**JOINT REGIONAL PLANNING PANEL  
(Sydney East Region)**

<b>JRPP No</b>	2016/SYE029
<b>DA Number</b>	LDA2015/0655
<b>Local Government Area</b>	City of Ryde
<b>Proposed Development</b>	Stage 1 Development Application for the mixed use redevelopment of the Macquarie Centre
<b>Street Address</b>	197-223 Herring Road, Macquarie Park
<b>Applicant</b>	AMP Capital Investors Limited
<b>Number of Submissions</b>	13 submission received. 11 submissions objecting to the development and 2 submissions supporting the development.
<b>Regional Development Criteria (Schedule 4A of the Act)</b>	General Development over \$20 Million
<b>List of All Relevant S79C(1)(a) Matters</b>	<ul style="list-style-type: none"> <li>• State Environmental Planning Policy (State and Regional Development) 2011</li> <li>• State Environmental Planning Policy No. 55 (Remediation of Land)</li> <li>• State Environmental Planning Policy (Building Sustainability Index: BASIX)</li> <li>• State Environmental Planning Policy No. 65 – Design Quality of Residential Flat Development</li> <li>• State Environmental Planning Policy (Infrastructure) 2007</li> <li>• Deemed State Environmental Planning Policy Sydney Regional Environmenta

Figure 16. The applicant intends to provide further landscape planting and potential architectural treatments added to the building in the locations indicated in yellow. Source – Urban Design Report prepared by AJ+C.

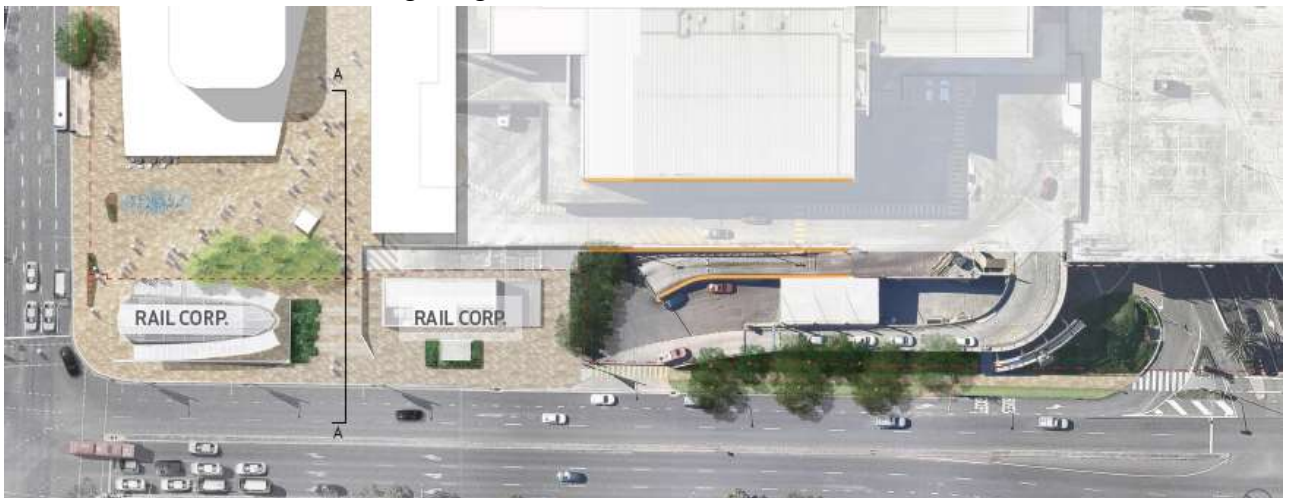
*Waterloo Road is the primary north-south spine in the future plans for Macquarie Park corridor, as described in the DCP. The Panel is concerned that the planting now proposed along the street edge is insufficient by itself to screen the vehicle ramps / entry points and service entries. The treatment should include built elements such as screening to existing car park structures, walls, roofing/pergola as well as landscaping to ensure a robust and permanent solution. It is understood that the Applicant is investigating possible new cladding to some of the building facades facing the street and this approach is supported.*

Concerns are raised that the landscaping proposed by the applicant may not be possible due to the number of services that are provided within Waterloo Road. It is agreed with the Panel that the Waterloo Road elevation does require some type of screening to improve the visual appearance of the existing vehicle ramps/entry points. Photograph 11 demonstrates the existing access arrangement and clearly demonstrates the unattractiveness of this particular entrance.

The applicant has proposed new screen planting along Waterloo Road and potential architectural treatments to be added to the existing building façade. This is demonstrated in the following diagram.

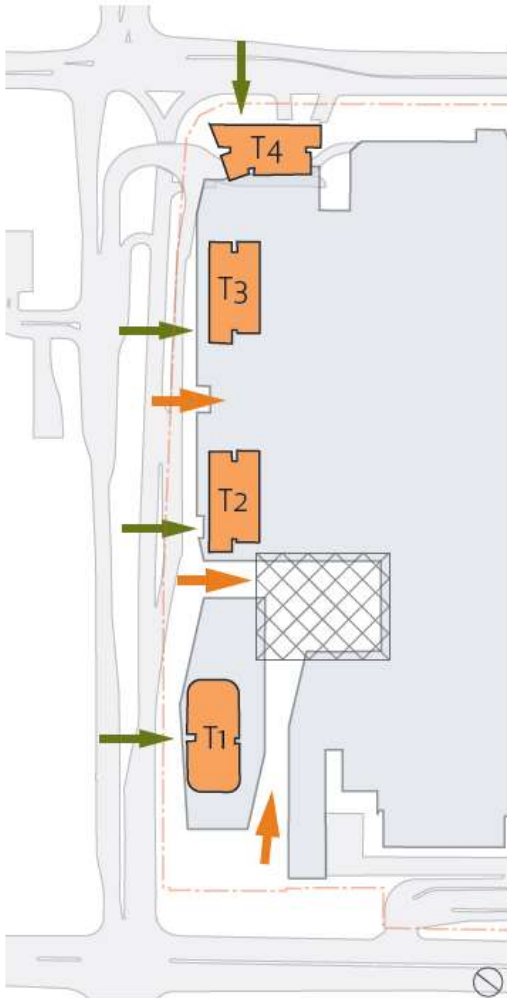
*With so much uncertainty surrounding the design of the proposed bus interchange in Herring Road, notably the potential for the main town centre plaza to be located there, the Panel strongly recommends that approval of the application be deferred until such time as the plans for Herring Road are developed and available for consideration.*

The concerns raised by the Panel in respect of the Herring Road entry are not supported. The entry is in a similar position to the existing entry however the width of the entry will be increased to 15m which will provide a greater sense of space.

**Comment:** The UDRP have raised several concerns in respect to the various plaza spaces associated with the development. No objection is raised to Station Plaza as the location of Station Plaza is consistent with Part 4.5 Macquarie Park Corridor of DCP 2014. This space will provide a valuable connection between the University, Shopping Centre and Railway Station. Condition 17 specifies criteria for the design and layout of this space which should ensure that the plaza will be an active area. The development application does not involve any future upgrading of the bus interchange other than street upgrades and kerb alignment. While consideration is

being given by the State Government to an unsolicited proposal to upgrade the Herring Road bus interchange, the current application is not dependent upon this proposal. Deferral of the development application until the bus interchange plans are known is not necessary or recommended.

Figure 17. The location of tower 1 is dependent upon its use. If it is entirely residential it will be located over the podium. If it is commercial the footprint will be enlarged over the retail laneway. Source – Urban Design Report prepared by AJ+C.

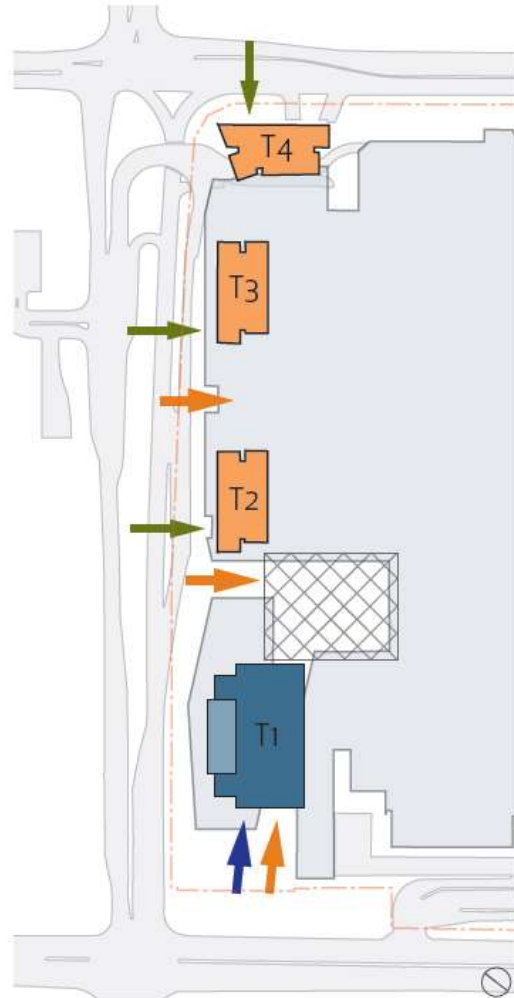
**Comment:** The Panel are concerned in respect of the use of Tower 1. If this tower is residential, it will be located entirely above the podium. However if it is a commercial tower the footprint will be bigger and the tower will be erected over part of the retail arcade. This is demonstrated by the following diagrams:
